**Assessment of Recent Soil Vapor
Investigations in the South Hill Area
of Ithaca, New York**

Prepared for:
NCR Corporation

Prepared by:
ARCADIS
6723 Towpath Road
P.O. Box 66
Syracuse
New York 13214-0066
Tel 315.446.9120
Fax 315.449.0017

Date:
February 2008

FIGURE
2B

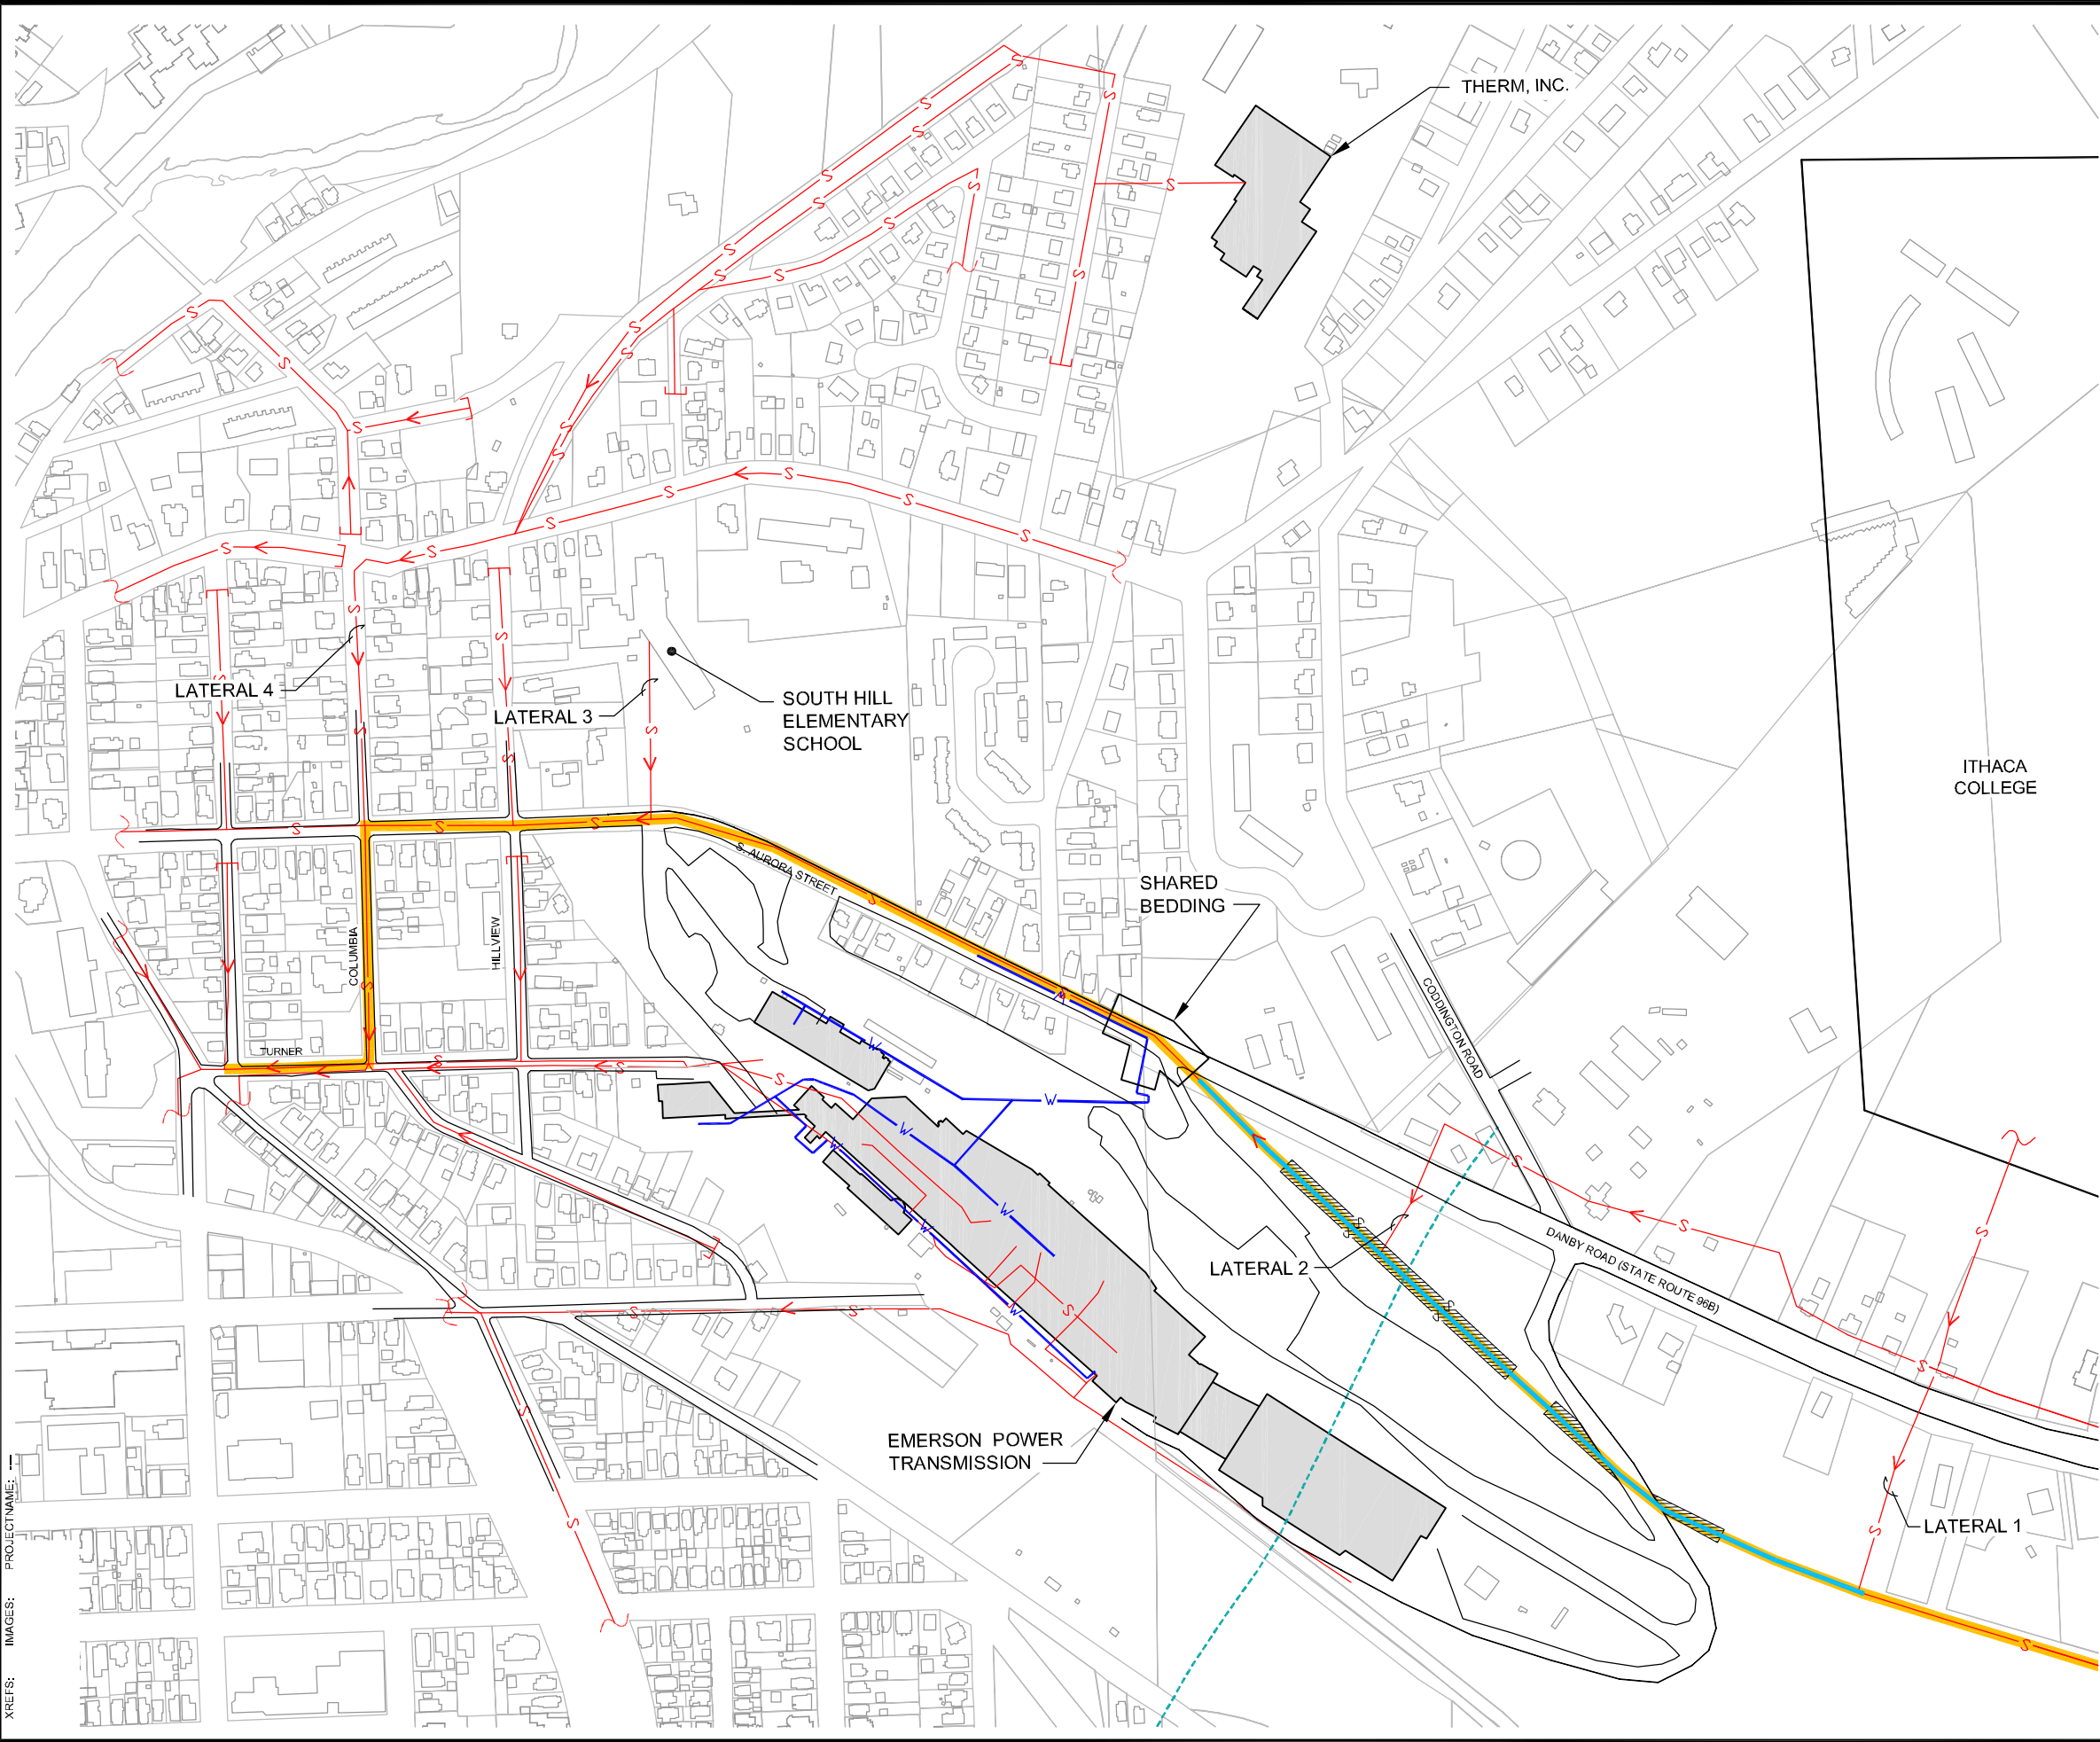
ARCADIS performed an evaluation of the South Hill sewer network relative to inferences made by the NYSDEC that alleged (and unsubstantiated) historic releases of TCE by NCR to the sanitary sewer system have resulted in possible vapor intrusion impacts at various locations north of 950 Danby Road. This evaluation included a review of drawings obtained from the City of Ithaca and Town of Ithaca Municipal Offices as well as discussions with Mr. Scott Gibson of the City of Ithaca Water and Sewer Department. The review targeted the sewer piping network in the area along Danby Road between 950 Danby Road and the Emerson facility and portions of the residential neighborhood to the north of Emerson. A general layout of the South Hill Area sewer network is presented on Figures 2A and 2B. Our findings following this review are summarized below:

ARCADIS' review of the Danby Sewer Line drawings identified an area on the northwest side of the Emerson property where the potable water supply shares bedding with the Danby Sewer Line. This instance of shared bedding presents a potential pathway for TCE-contaminated soil gas to migrate to the Danby Sewer Line bedding. No investigation has been performed of this potential migration pathway.

FIGURE
3

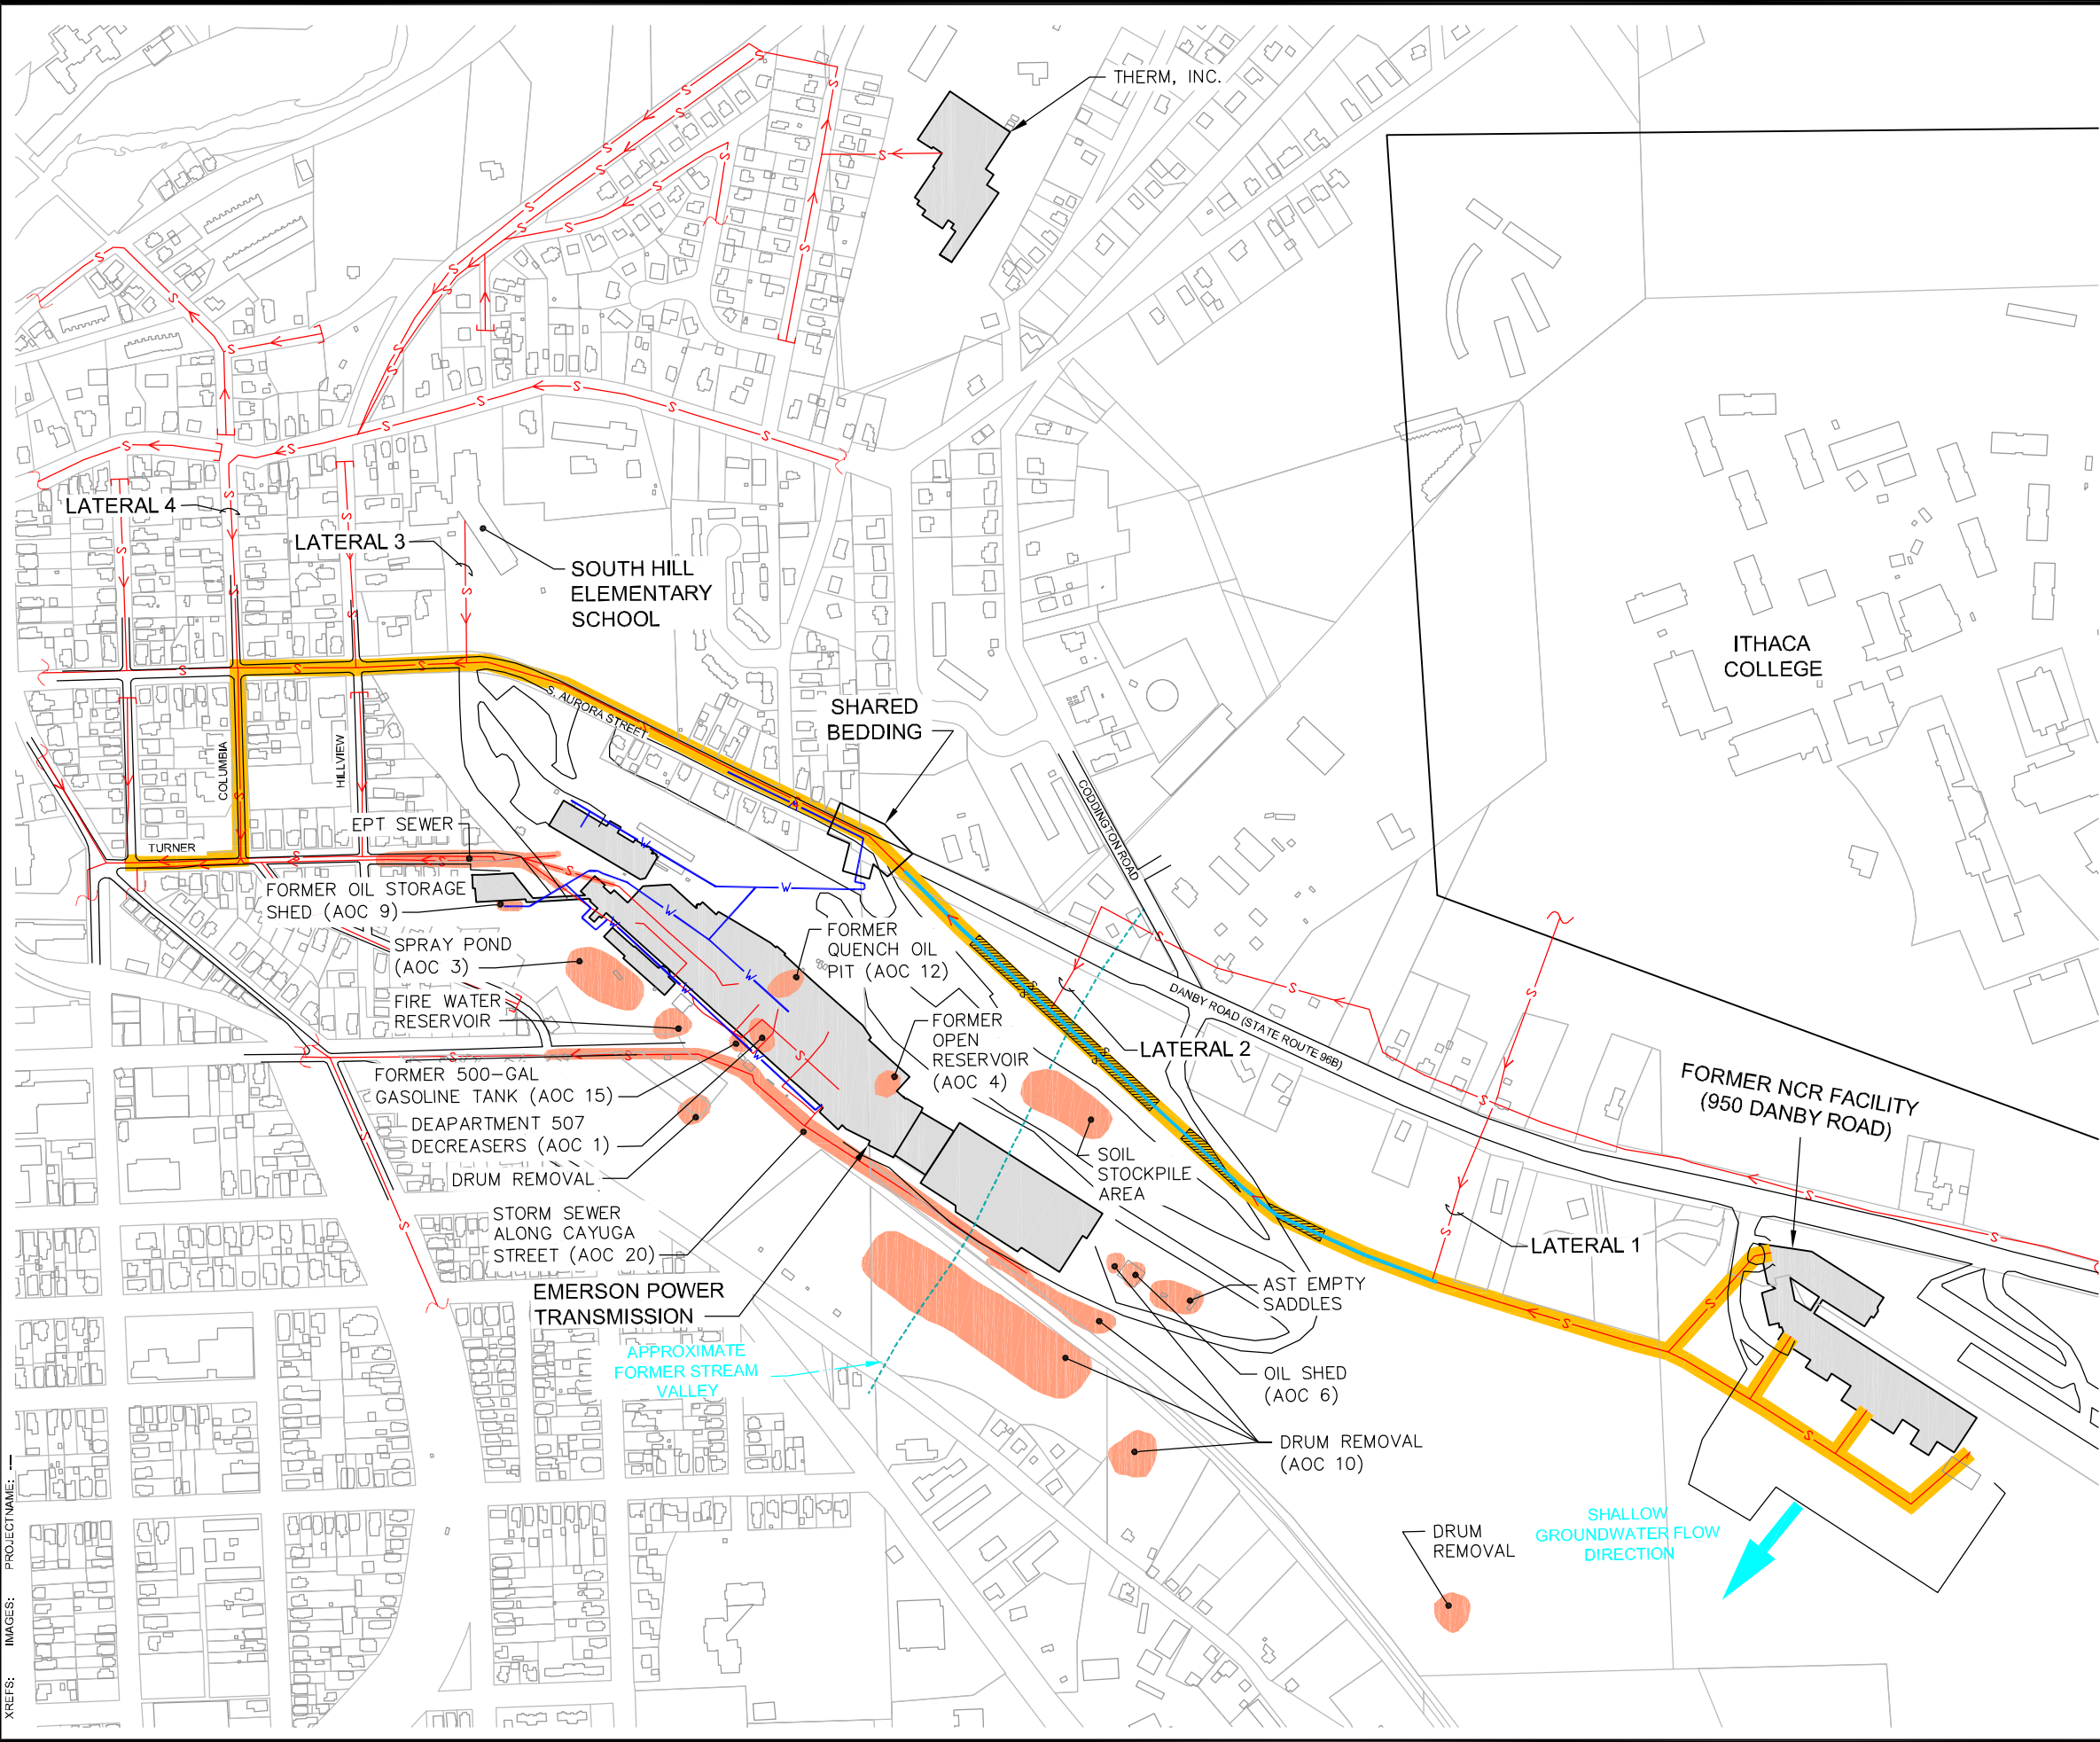
Numerous additional sources of information were reviewed related to potential environmental concerns associated with the Emerson facility including aerial photographs, and documentation associated with NYSDEC oversight of remedial programs undertaken by Emerson. Detailed information obtained during a review of available information is provided in Appendix 4. This information indicates that numerous remedial programs have been undertaken to address environmental areas of concern throughout numerous areas on the Emerson property. The location of areas of concern referenced in Appendix 4 are shown in Figure 3.

1980-1982 – Between 75 and 100 drums were removed from an area near the oil shed, which is shown as AOC 6 on Figure 3.

1987 – A total of between 201 and 236 drums were removed during this mobilization at the following locations as shown on Figure 3:

- 55-60 drums were removed from an area above the railroad bed which is shown as AOC 10 [50-60 Drums (former)]
- 6 drums were removed from the ravine below the outfall which is shown as AOC 10 [6 Drums (former)]
- 20 drums were removed down the hill from the NYSEG substation which is shown as AOC 10 [20 Drums (former)]
- 120-150 drums were removed down the hill from the railroad bed which is shown as AOC 10 [120-150 Drums (former)]
